TOLEDO - LUCAS COUNTY PLAN COMMISSIONS

REF: SUP-5009-23

SUBJECT: Amendment to Special Use Permit, Originally Granted by Ord. 619-84 and Ord. 53-95, for Gas Station Modifications at 310 W Alexis Road

SITE PLAN

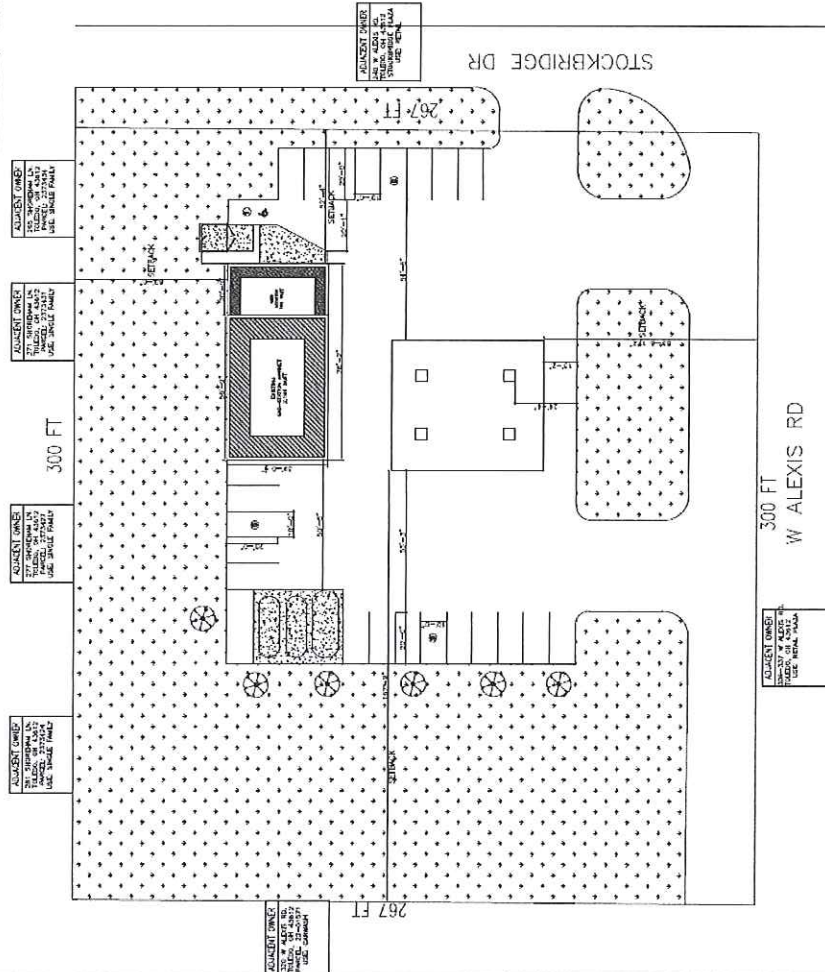
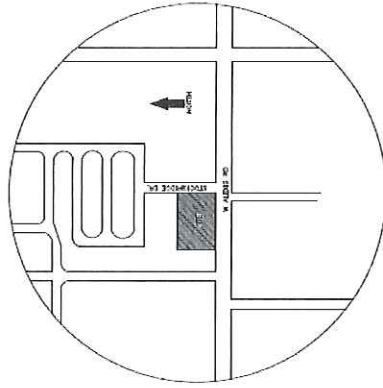
Per TMC§1104.0900 and TMC§1107.1600, gasoline pump islands require one (1) stacking space at each pump island. This use specific requirement for the depiction of vehicle stacking will require a revised site plan. The architect shall reference TMC§1107.1602 for proper depiction of vehicle stacking on a site plan.

Per TMC§1107.1701-*Accessible Parking Spaces for Physically Disabled Persons*, the site is required to have one (1) van accessible parking space. The van accessible space must include an eight foot (8') wide aisle abutting the space to allow room for wheelchair accessibility. Additionally, the space must be in close proximity to the building entrance and allow individuals access to the building via an unobstructed path. The site plan shows an accessible space with no abutting aisle, as it is directly abutting the dumpster enclosure. The Division of Traffic Management is requiring this space be removed to prevent the dumpster enclosure gates from swinging into a parking space. Staff support the Division of Traffic Management's condition of approval; the parking space adjacent to the dumpster enclosure be removed, and two (2) existing spaces shall be designated for a van accessible space.

Lastly, the Division of Traffic Management is requiring the closure of the easternmost curb cut on Alexis Road. A revised site plan depiction this closure is required as a condition of approval.

14. Vehicle stacking must be clearly shown per TMC 1107.1602. (Gas pumps locations must be shown for vehicle stacking requirement.)
15. One van accessible parking spot is required to be shown with an 8' loading aisle per TMC 1107.1701 & 1107.1202.

18. A 25' drive aisle is required for two-way traffic between vehicle stacking and the building per TMC 1107.1911.
19. Drive approaches must be clearly dimensioned per TMC 1107.1911.

20. Garbage enclosure gates are not allowed to swing into a parking spot.
21. Existing drive approach and curb cut closest to Stockbridge Drive on West Alexis Road must be removed with new grass and curb installed to match adjacent curb and grass areas.

26. One (1) accessible space is required with an eight foot (8') aisle abutting the parking space. **Not acceptable as depicted. Proposed accessible space shall be removed to allow space for dumpster enclosure gates, and two (2) existing spaces shall be utilized for a van accessible parking space.**

- d. Dumpster screening per TMC§1108.0203(G) is required. **Dumpster enclosure details shall be provided on a revised site plan or landscape plan.**
